SERVICE BULLETIN

PURPOSE : INFORMATION	ISSUE NO. : MSB-10E42-001	DATE : 2010-07-05
SUBJECT : HOOD INSULATOR MOUNTING CLIP AND HOOD WEATHERSTRIP FRONT		<MODEL> (EUR/RUSSIA) ASX (GA0W) <M/Y> 11
GROUP : BODY

HOOD

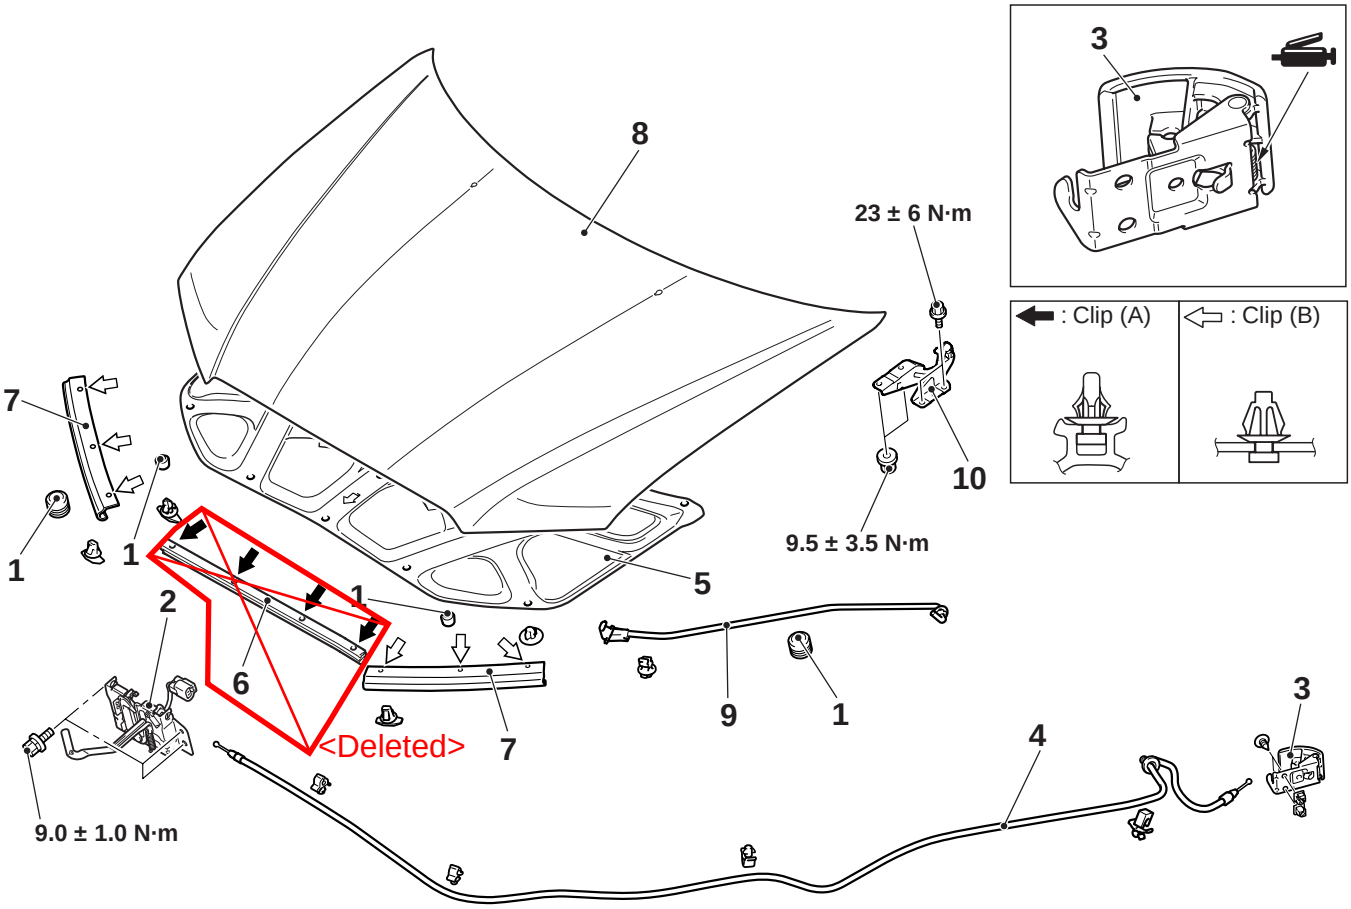
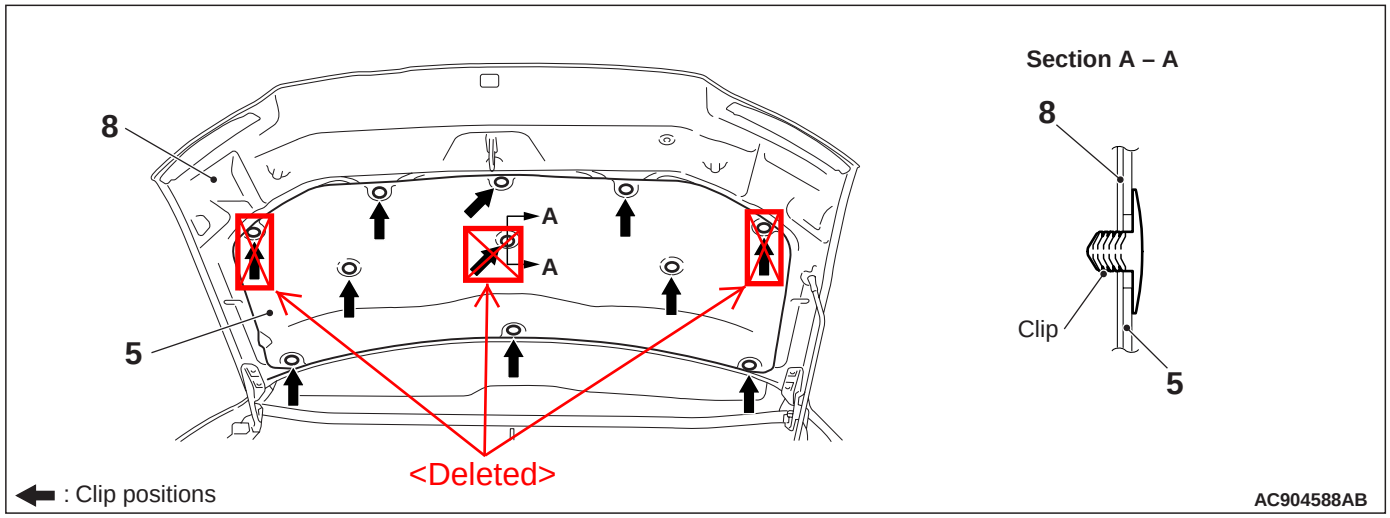
The following changes are introduced to improve productivity.
- Number of clips are reduced from 11 to 8.
- The hood weatherstrip front is discontinued.

<Deleted> 6. ~~Hood weatherstrip front <if so equipped>~~
